PROJECT: 21 DEANE STREE LOT 1, COTTESLOE 6011  
DRAWING: FIRST FLOOR PLAN  
CLIENT: Kate Moore

# Proposed Two-storey Dwelling with Undercroft Garage

**RE: SUBMISSION ON PROPOSED TWO STOREY DWELLING WITH UNDERCROFT – LOT 18 (NO. 21)  
DEANE STREET, COTTESLOE**

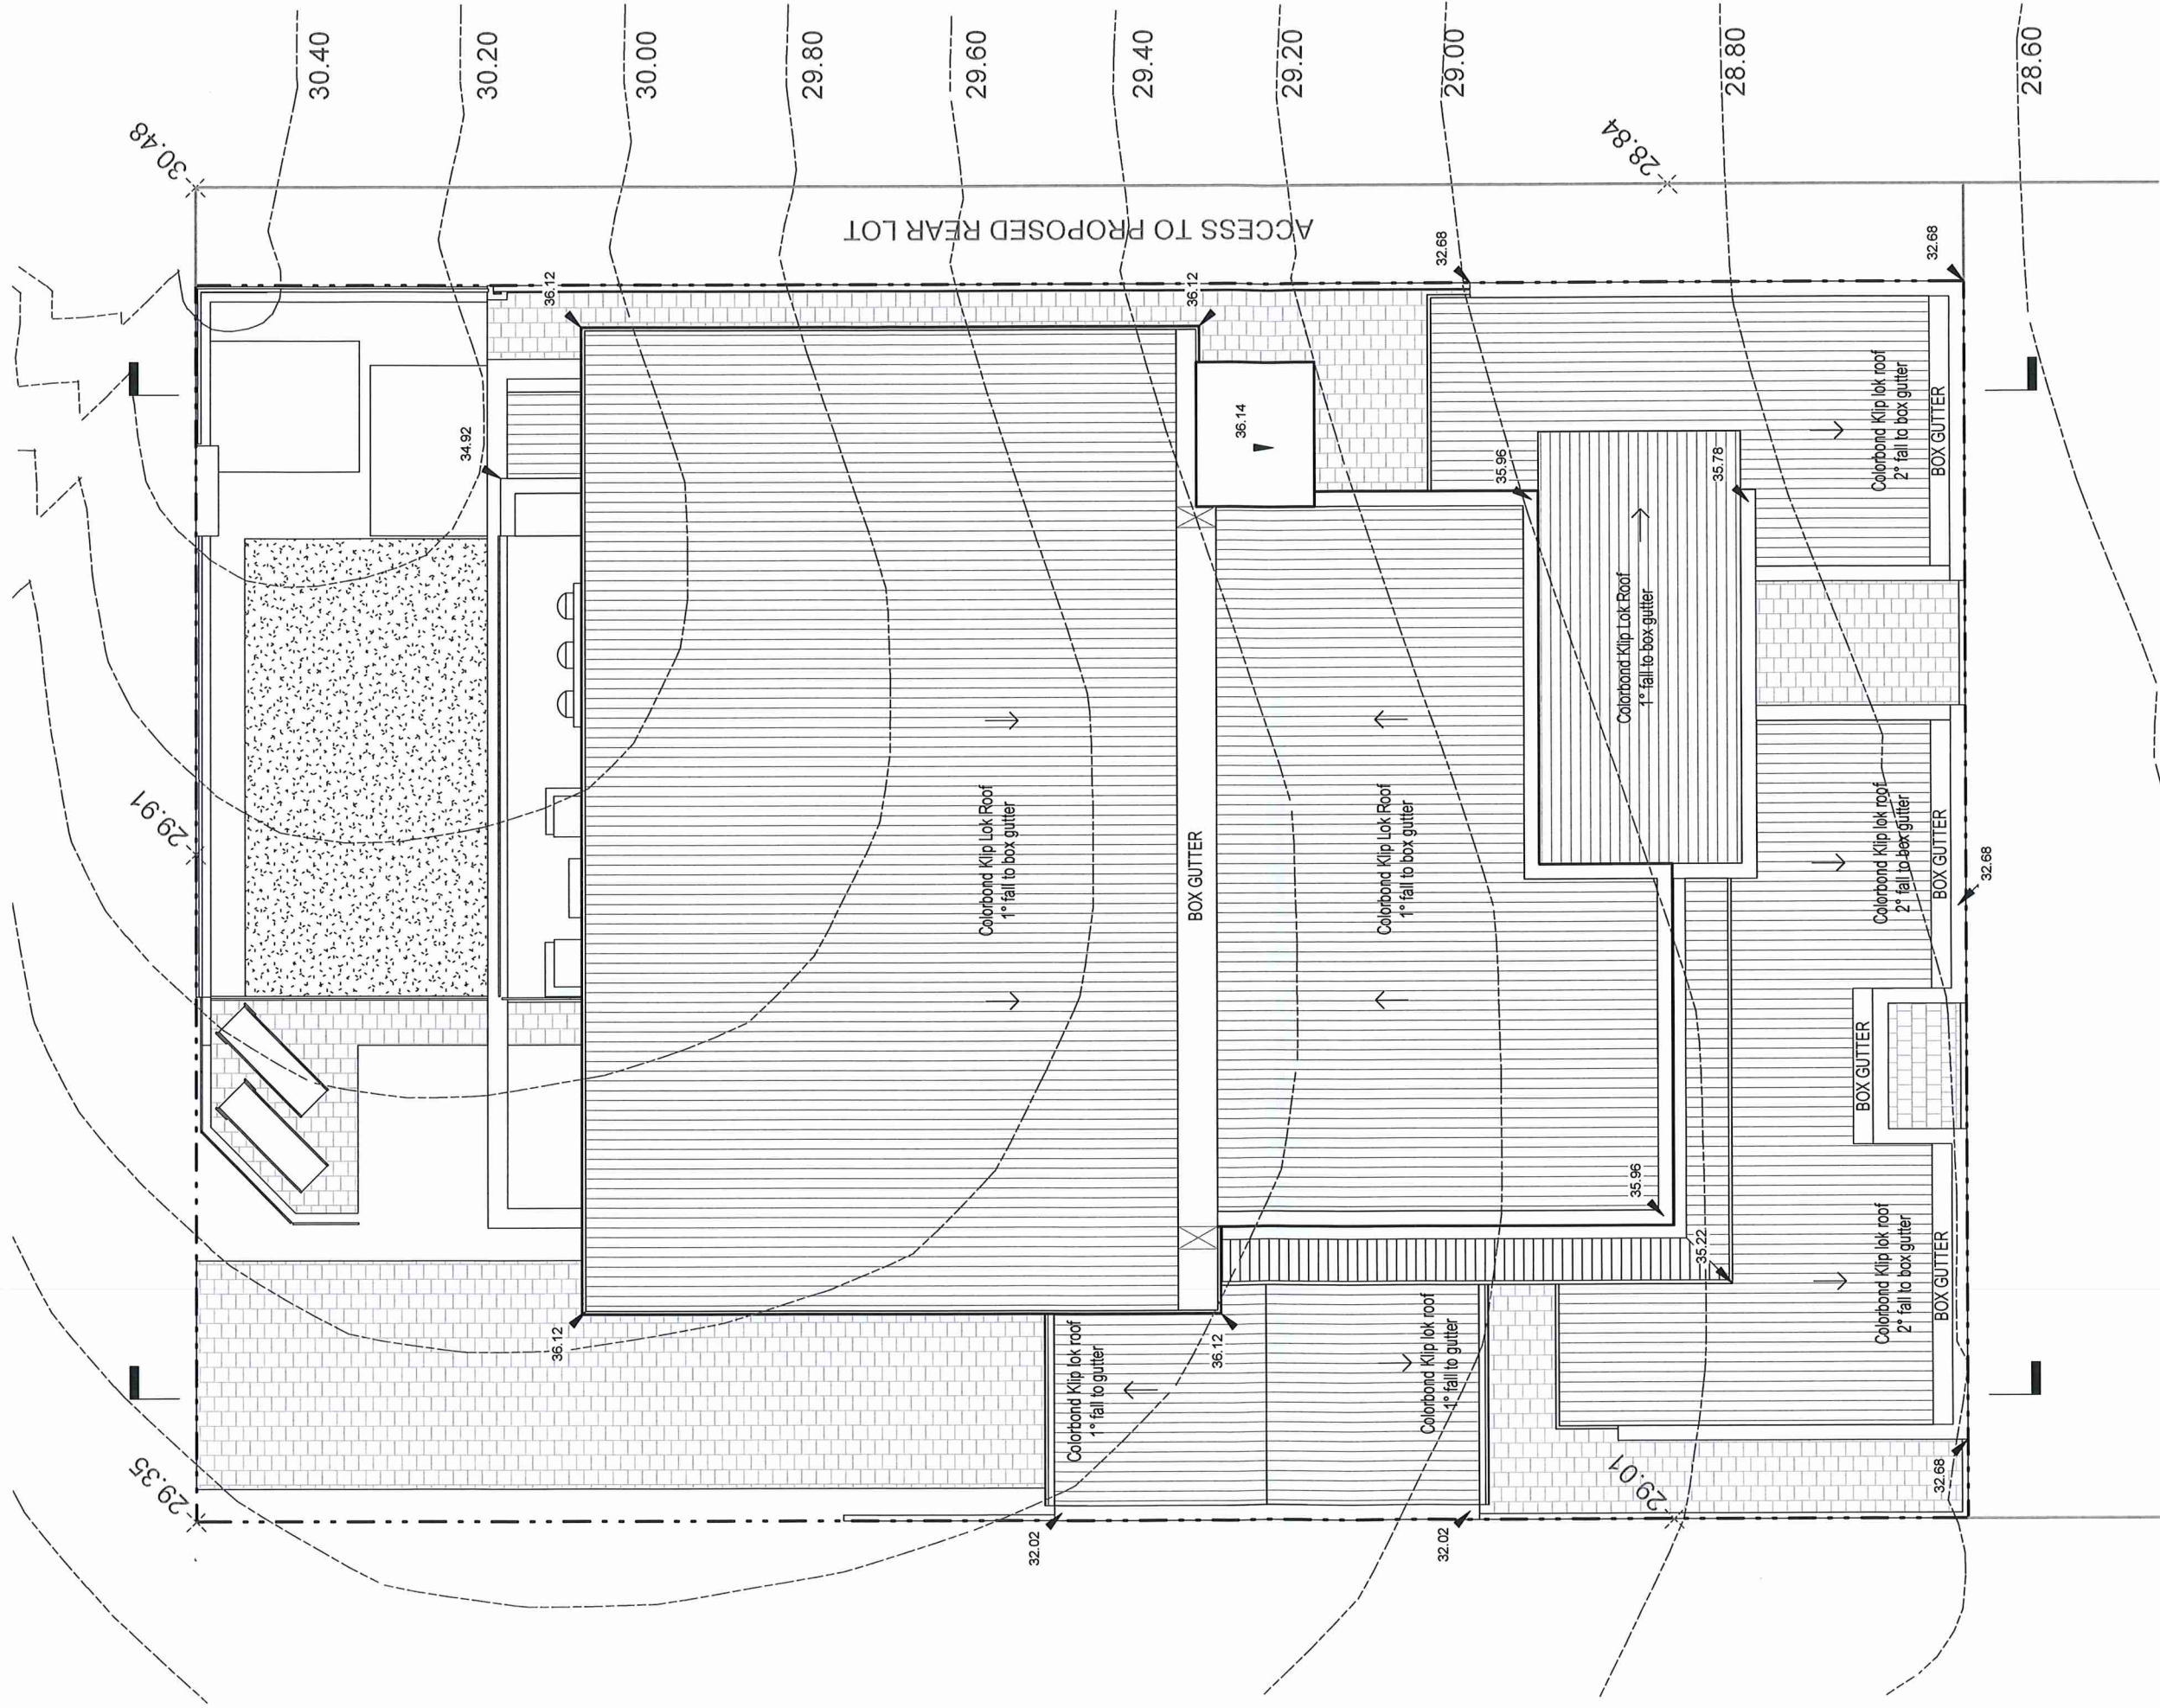
- Eastern Setback to upper floor – Overall wall length = 19.3m. Height <7m with a major opening to a habitable room (Study/Bed 4) requires a setback of 5.5m. Proposed is 4.68m.

- The Eastern wall on the proposed plans of the first floor balcony completely blocks our view of the ocean. Rather, we would be happy to sign off on our pool to be overlooked, and therefore for that wall to be set-back to the same distance as the street-scape.

DRAWING: ROOF PLAN

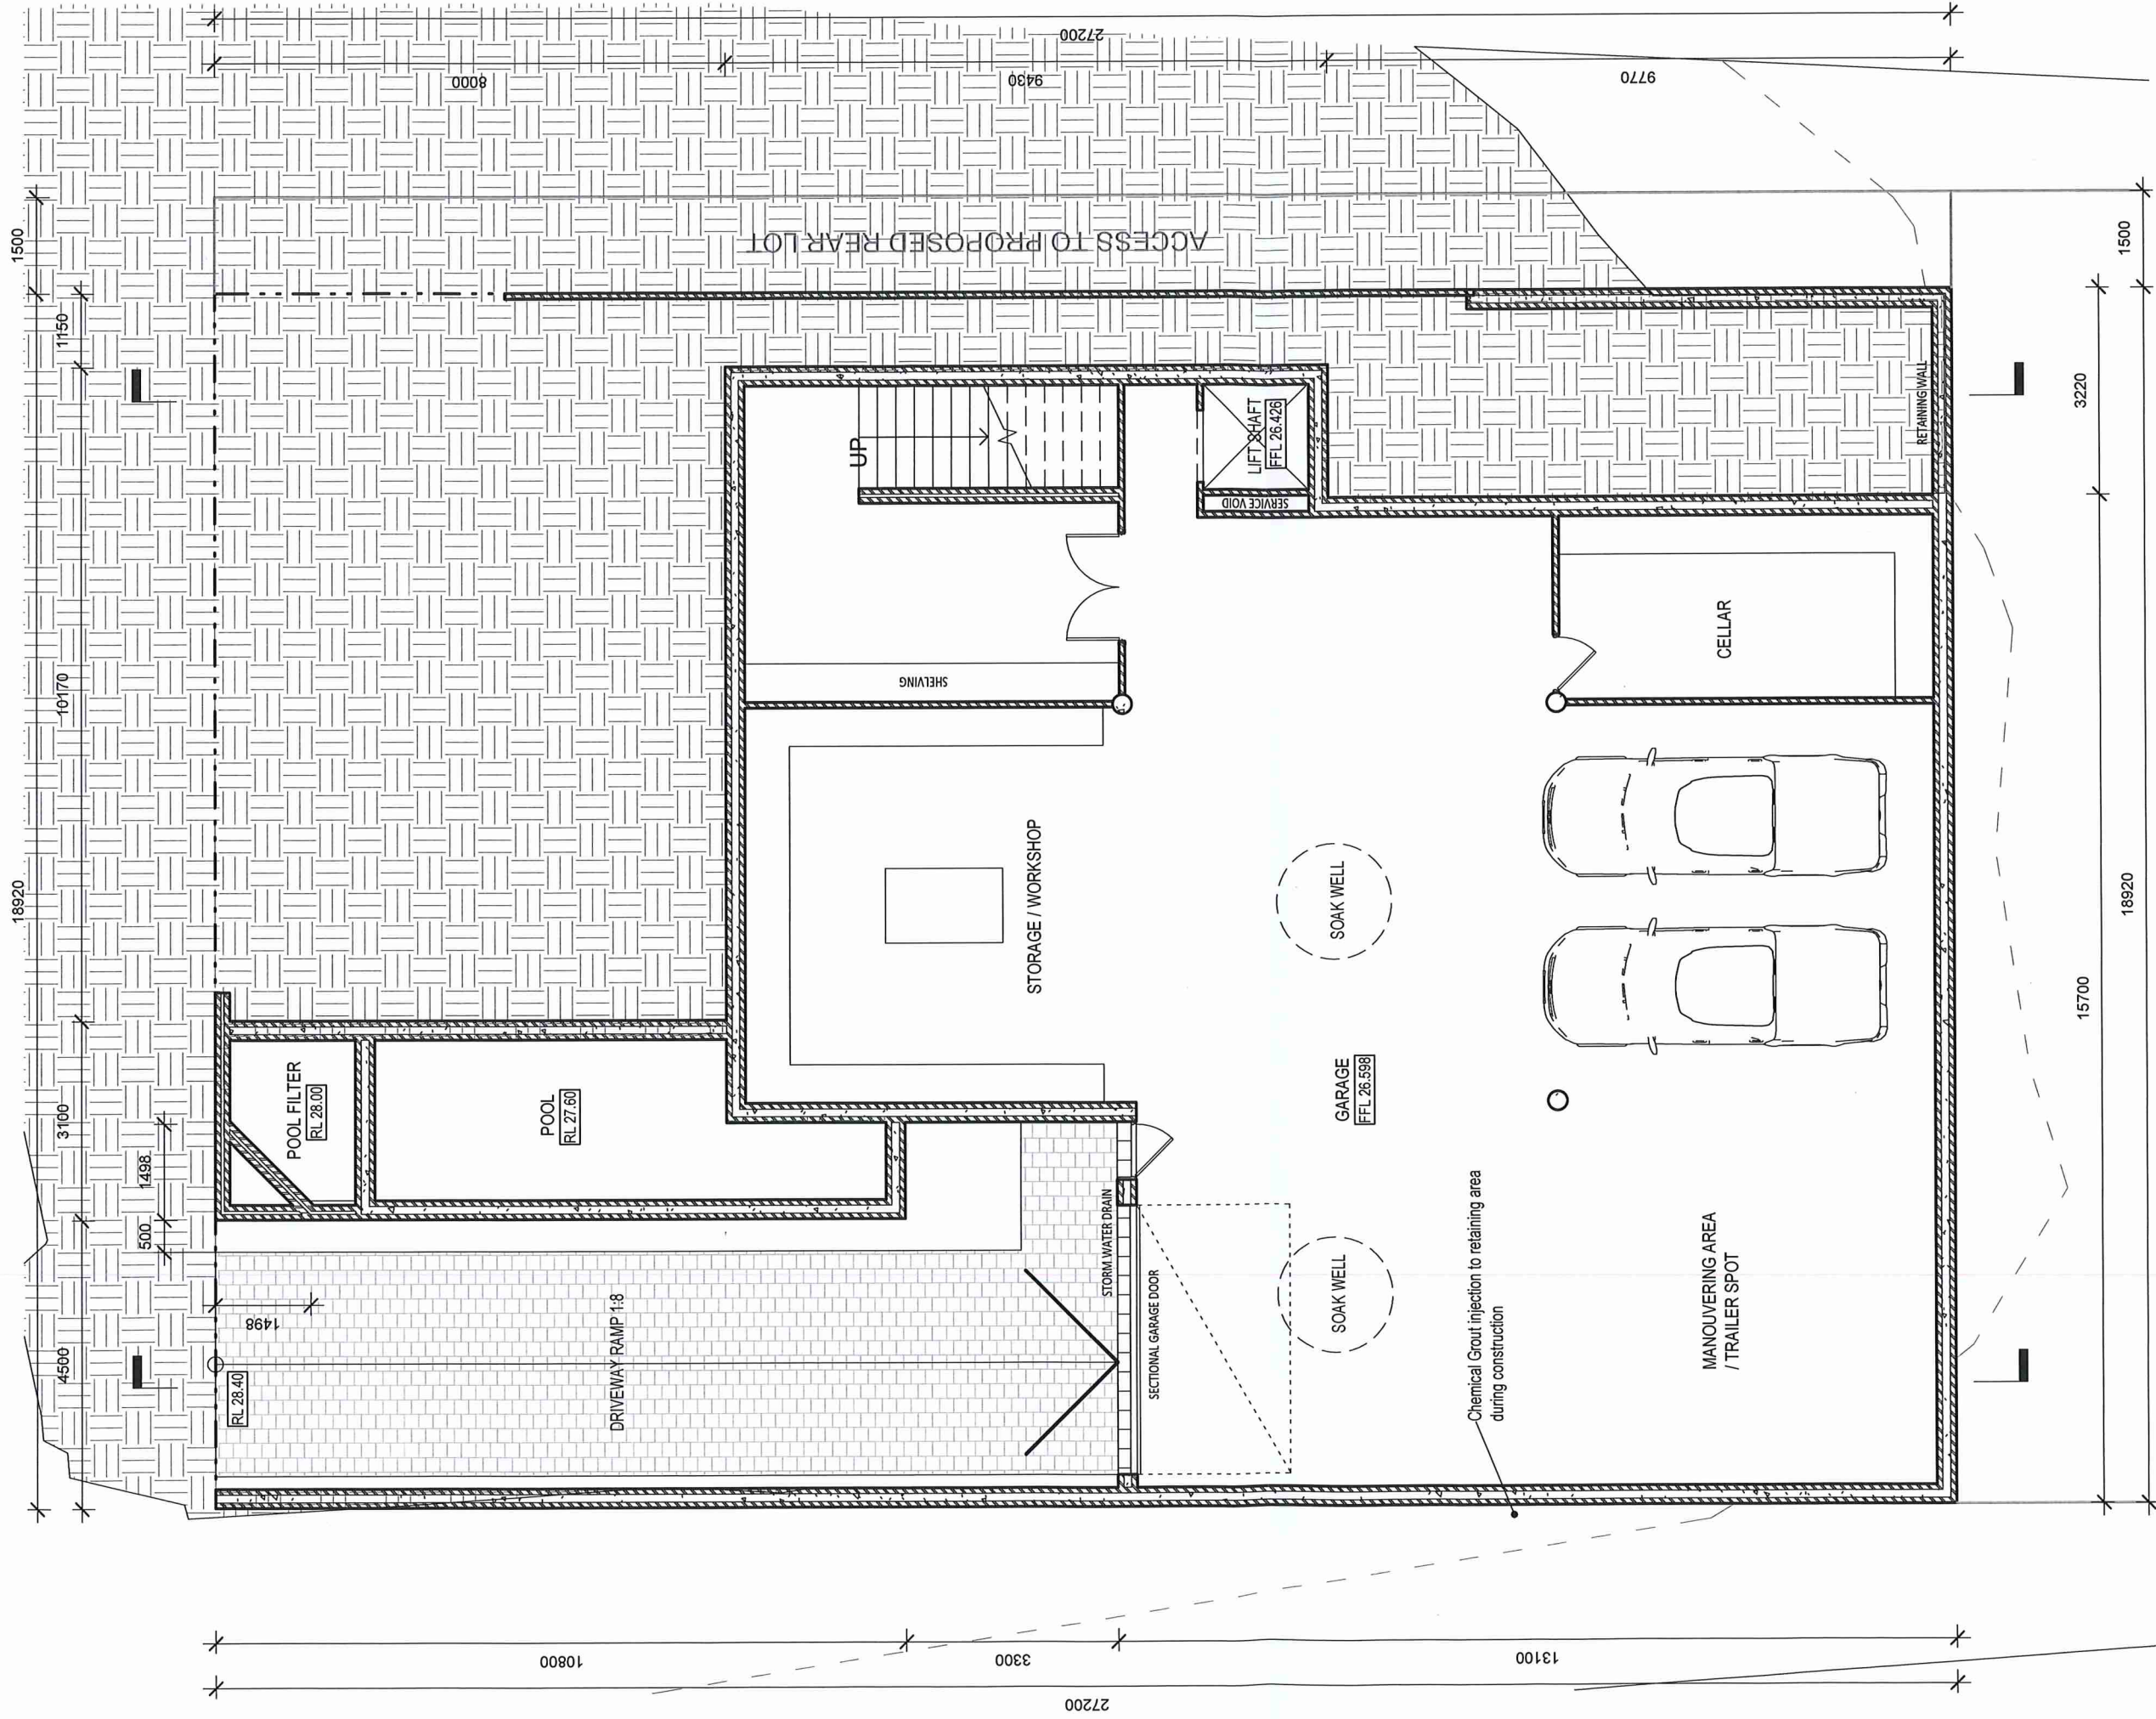
Based on observations of the subject site, the existing ground levels appear not reflect the TPS1 contours as provided for on Plan DA05 which clearly show a rise in elevation to the north-eastern corner. The existing levels within the subject site appear to be built up through the central portion of the site and along the western boundary. Any variations between TPS1 contours and existing levels which have the potential to result in further exceedances to building and wall height ought to be monitored during the construction phase to ensure compliance with approved levels.

- The roof height of the proposed dwelling at the southern end is shown on Plan DA05 as 35.96 being **10.03m above the FFL of the ground floor outdoor living area** of No. 24 Avonmore Terrace.
